Stepper driver motor with flying wires Part Number 551-02933-jvt

A New improvement to the reliability of the Mattson Aspen II system.

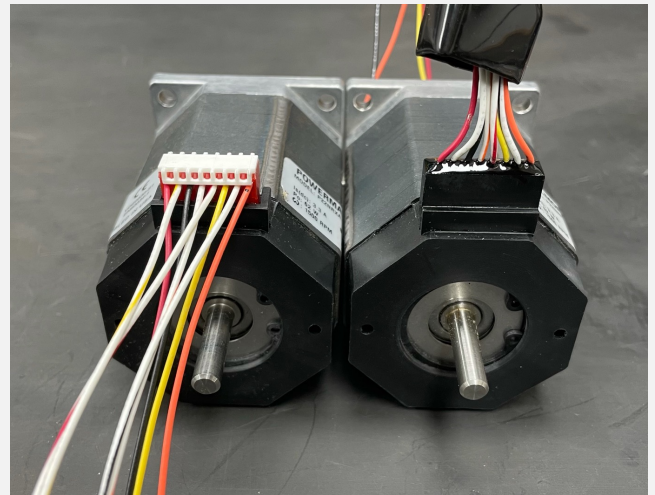
The original stepper driver motor for the robot lift movement has a plug and crimped wire connection. Over time this plug has become loose or a wire connection has become wobbly. Some tools has shown signs of an overheated crimp connection and even a melted plastic plug.

To improve this design a factory made up-grade motor with flying leads has been created. This welded joint not only improves the connection of the wires to the motor, it also improves the stability of the mechanical movement of the wires.
